# 1996 Corvette: Service Bulletin: 3 - 2 Part Throttle Downshift Flare

**Subject:** Service Bulletin: 3 - 2 Part Throttle Downshift Flare (Replace 3 - 2 Solenoid)

1996 BUICK ROADMASTER  
1996 CADILLAC FLEETWOOD  
1996 CHEVROLET CAMARO, CAPRICE, CORVETTE  
1996 PONTIAC FIREBIRD  
1996 OLDSMOBILE BRAVADA  
1996 CHEVROLET AND GMC C/K, M/L, S/T, G MODELS WITH HYDRA-MATIC 4L60-E (RPO M30)  
1996 HOLDEN COMMADORE "VS"  
**Source:** Chevrolet Dealer Service Bulletin  
**Bulletin Number:** 67-71-47

FIGURE 1 - HYDRA-MATIC 4L60-E TRANSMISSION IDENTIFICATION  
INFORMATION FIGURE 2 - HYDRA-MATIC 4L60-E TRANSMISSION  
IDENTIFICATION INFORMATION FOR TWO-PIECE CASE FIGURE 3 -  
LOCATION AND IDENTIFICATION OF THE 3-2 CONTROL SOLENOID ON THE  
CONTROL VALVE BODY

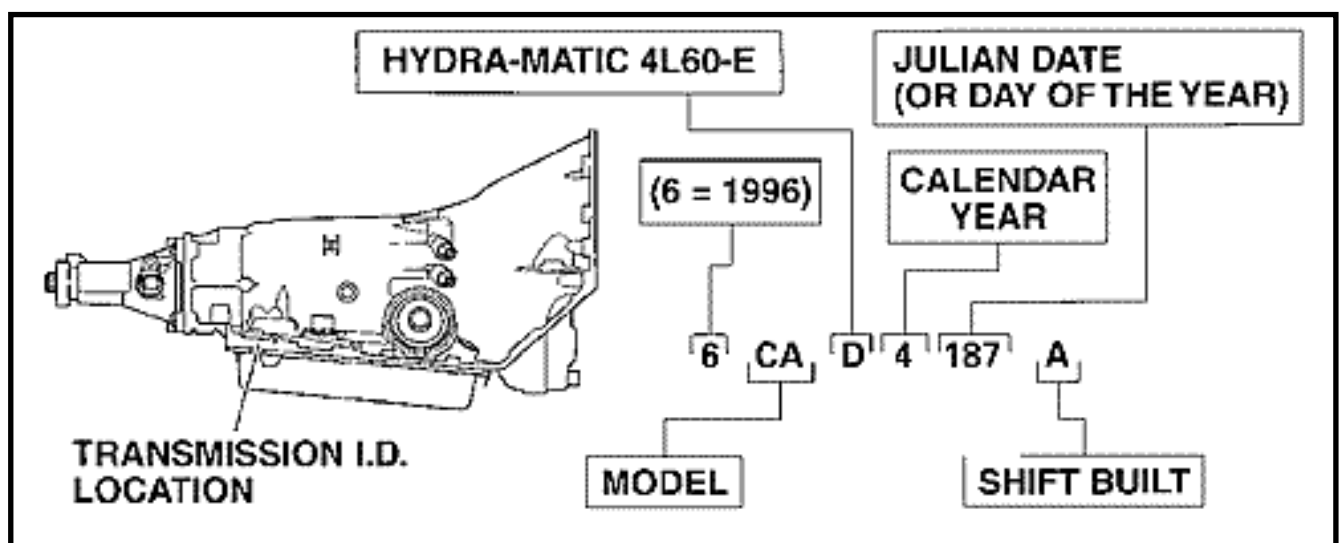
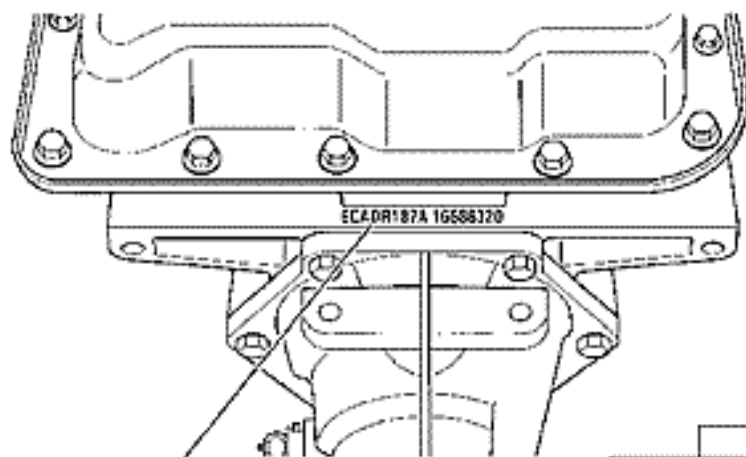
(FIGURES 1 AND 2)

SOME OWNERS OF THE ABOVE MODELS WITH A HYDRA-MATIC 4L60-E TRANSMISSION (BUILT BEFORE MAY 24, 1996/JULIAN DATE 6145) MAY EXPERIENCE AN ENGINE SPEED FLARE OF 1000-2000 RPM, DURING A PART THROTTLE DOWNSHIFT AT 19-31 MPH. THIS CONDITION WILL NOT SET ANY DTC'S (DIAGNOSTIC TROUBLE CODES).

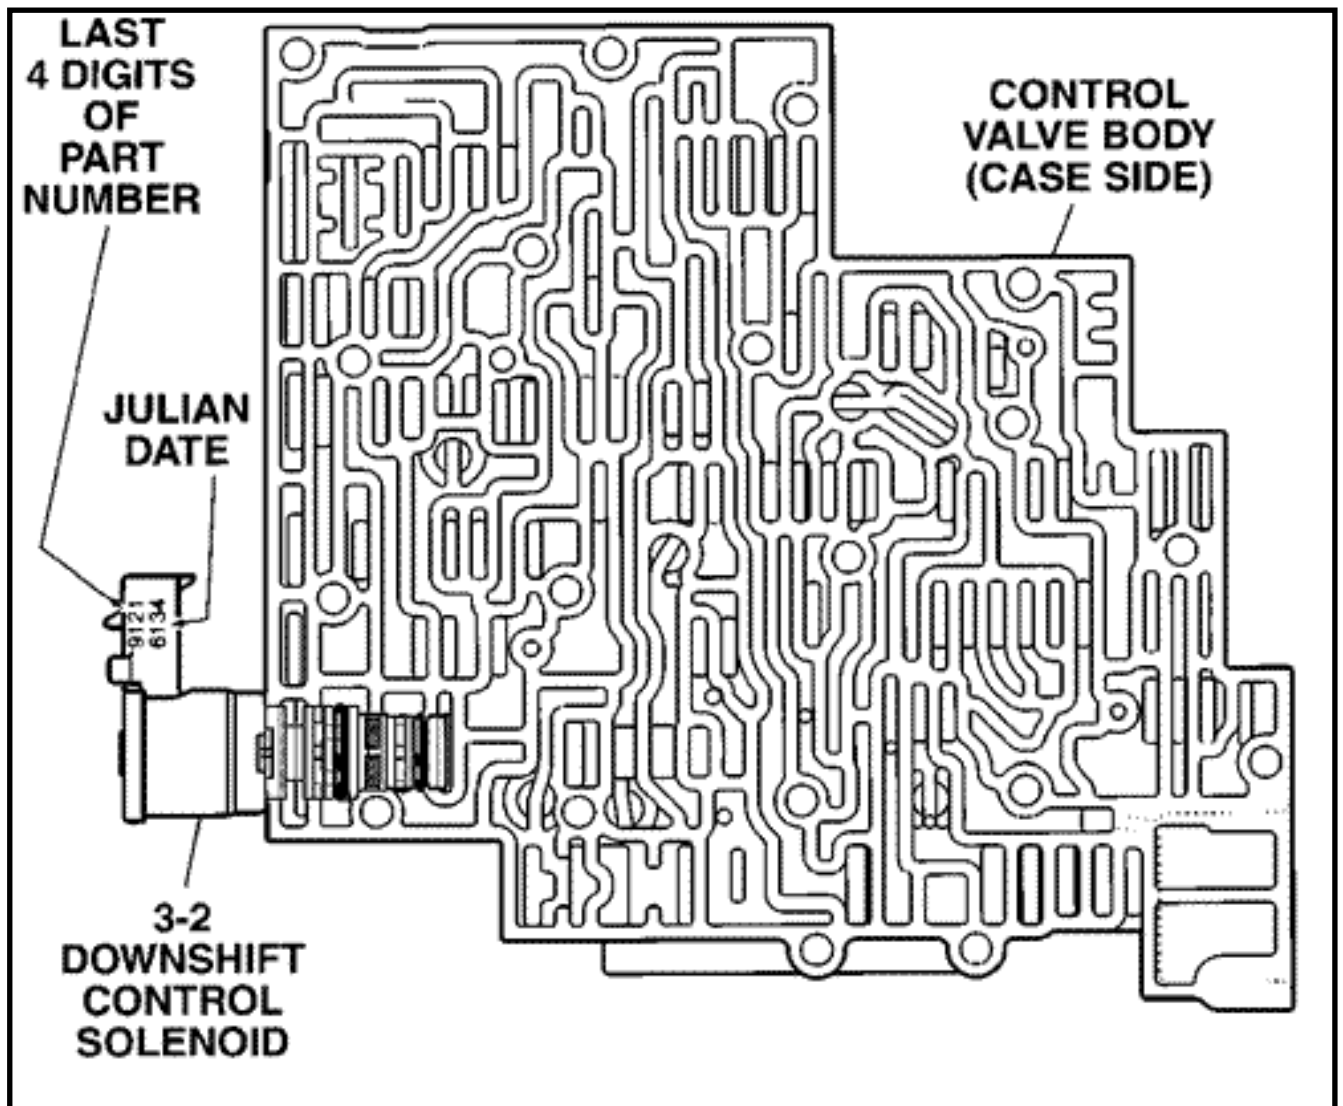
EXHAUST SEAT ON THE 3-2 CONTROL SOLENOID BACKING OUT.

(FIGURE 3)

REPLACE THE 3-2 CONTROL SOLENOID. JULIAN DATE ON THE SOLENOID WILL BE MAY 13, 1996 (6134) OR LATER.
